DUKE POWER COMPANY

Re: Catawba Nuclear Station, Unit 1  
Docket No. 50-413  
Draft Technical Specifications

Attachments 1-5 of this letter contain proposed amendments to the Draft Technical Specifications for Catawba Unit 1. Each attachment contains the proposed changes and a discussion of the justification.

TABLE 3.7-4

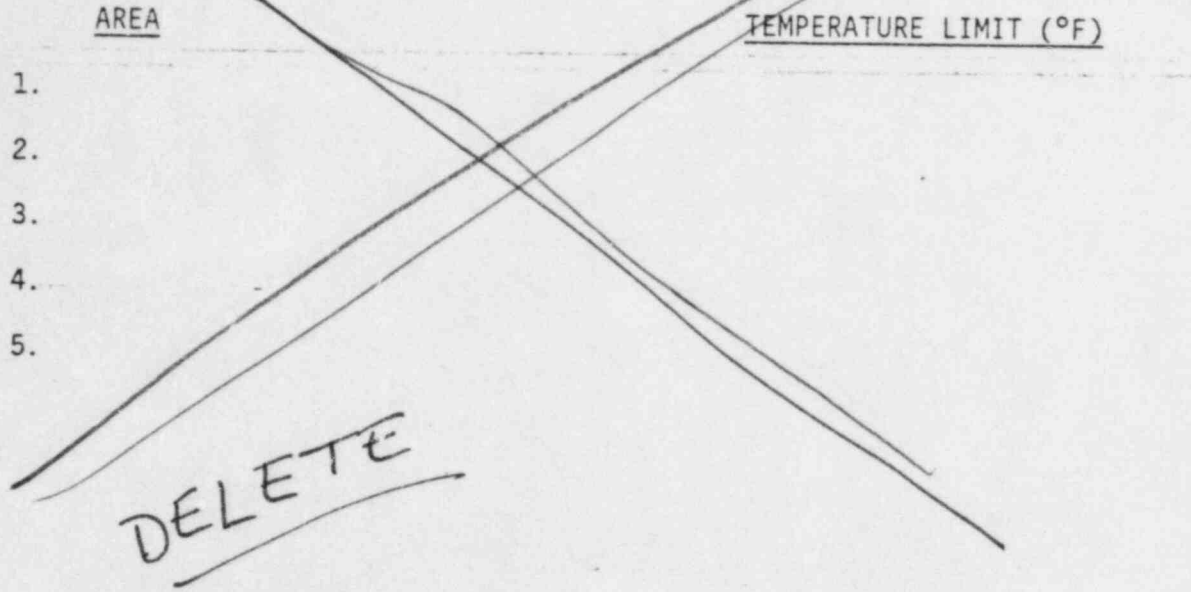
The proposed change would delete Technical Specification 3/4.7.12, Area Temperature Monitoring.

Based on the Catawba equipment qualification program and preventive maintenance and surveillance programs, it is concluded that an area temperature monitoring system as described in Technical Specification 3/4.7.12 is not required at Catawba.
